Meeting Summary

Project: I-64 Hampton Roads Bridge-Tunnel (HRBT) Expansion Project
Meeting Title: HRBT – Compensatory Mitigation and Pile Driving Workshop
Date: 06 November 2019, 900 to 1200
Location: VMRC – Building 96, 380 Fenwick Road, Fort Monroe

Comment Response

JPA Updates – Island Expansion

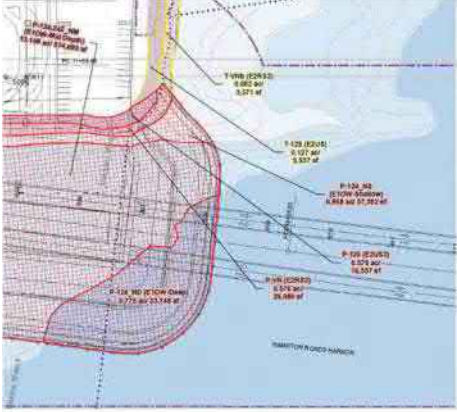
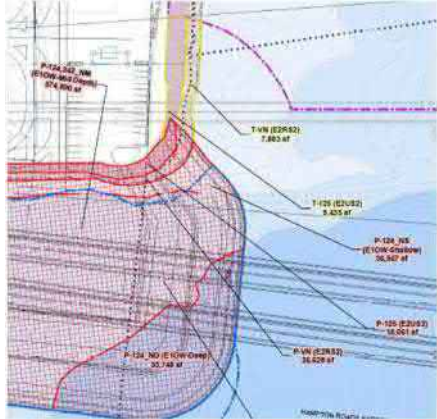
- Corner added for island expansion

JPA Updates – Trestle Increase

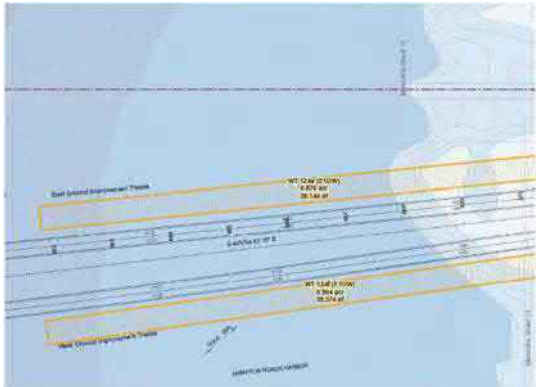
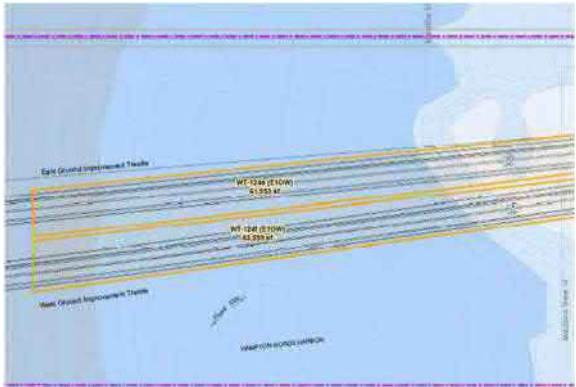
- Jet grout trestles increased in size

JPA Updates – Rip Rap

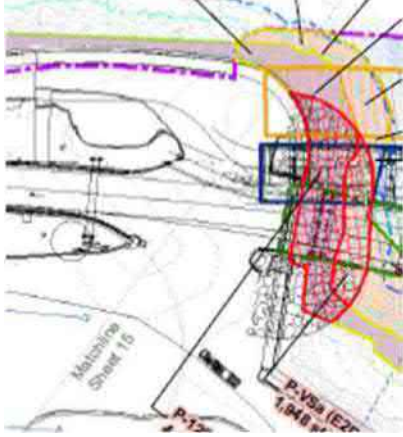
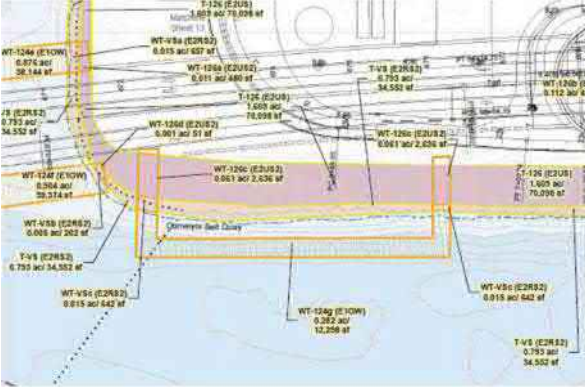
- Rip Rap added

JPA Updates – Conveyor

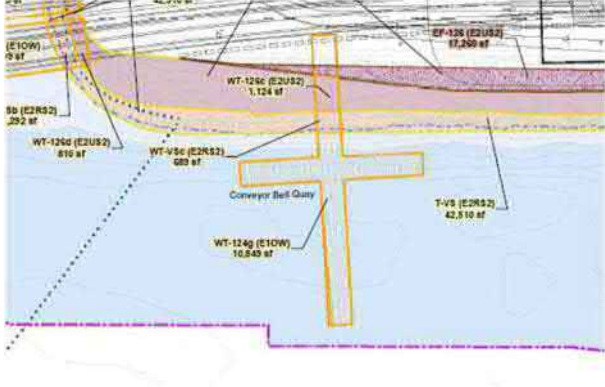
- Conveyor belt changed shape and size
